# 1963 - 1982 Corvette: Chevrolet Service News: Rear Spring Removal Service Update

**Subject:** Rear Spring Removal

**Model and Year:** 1968 Corvette

**Date:** August 1968

Fig. 6—Removing Corvette Rear Spring

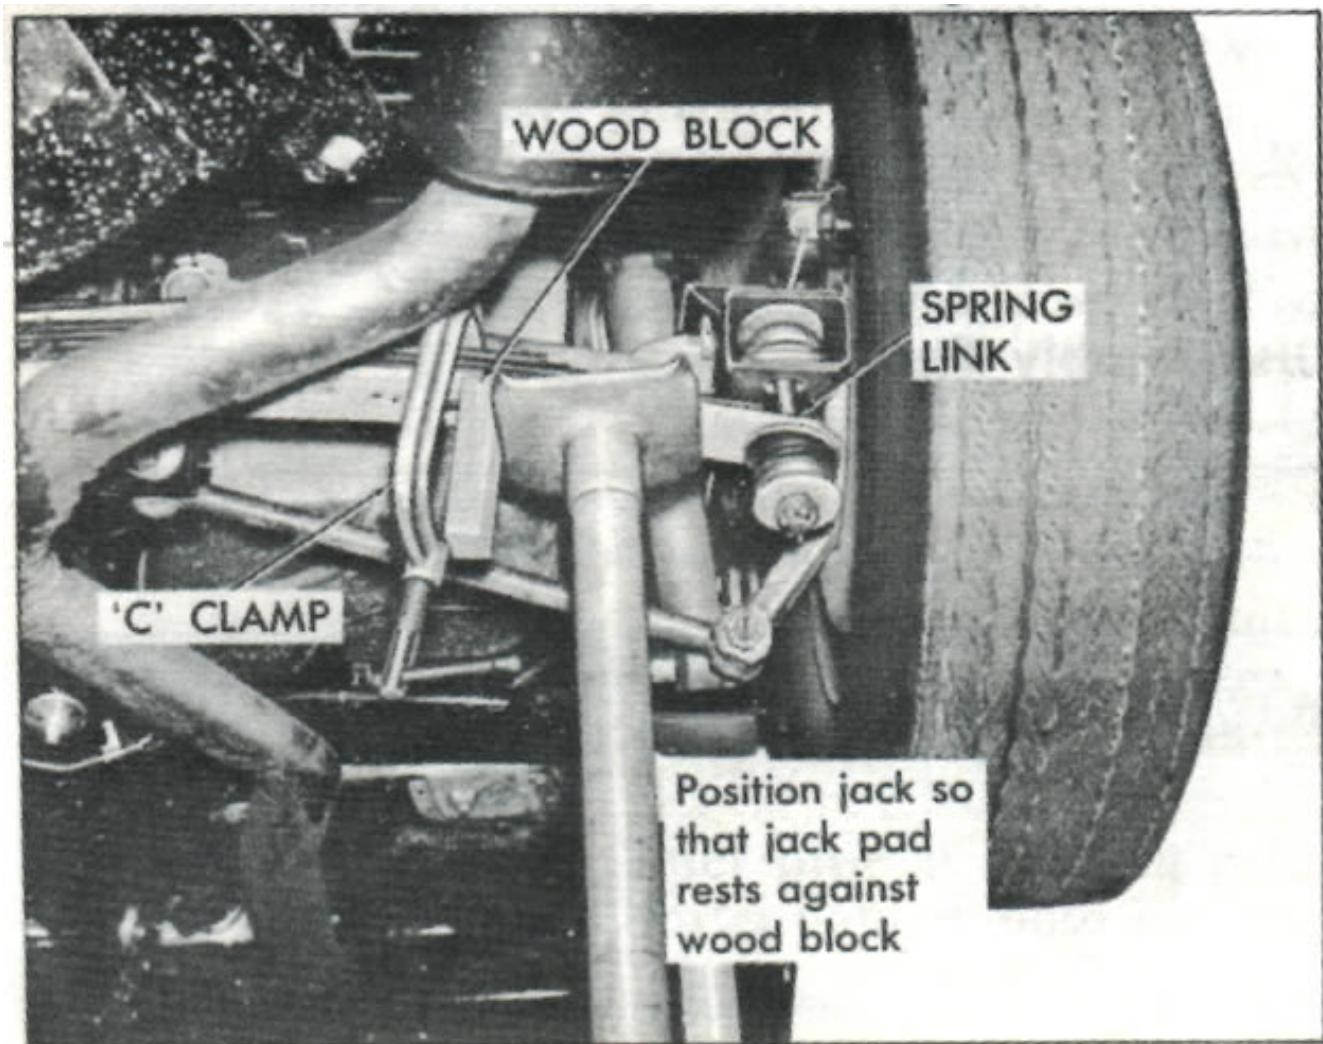
Revise the procedure appearing on page 4-20 of the 1968 Passenger Car Chassis Service Manual covering Corvette Rear Spring Removal as follows:

## Removal (Reference Fig. 6)

1. Raise rear of vehicle at frame.
2. Install "C" clamp on spring approximately 9" from one end. Tighten securely.
3. Place floor jack under spring with lifting pad of jack inboard of link bolt near the "C" clamp. Place a suitable piece of wood between jack pad and "C" clamp screw. *NOTE - The "C" clamp is merely acting as a 'stop' so that the jack won't slip when the spring is released. The wood block is used to protect the "C" clamp threads from being distorted due to contact with the jack pad.*
4. Raise jack until all load is off link. Remove link cotter key and link nut. Remove cushion.

5. Carefully lower jack until spring tension is released.
6. Repeat steps 2-5 for other side.
7. Remove four bolts and washers securing spring center clamp plate (reference Fig. 51 in Manual).
8. Drop spring and slide out from under vehicle (reference Fig. 51 in Manual).
9. To install, reverse Removal steps 1-8.
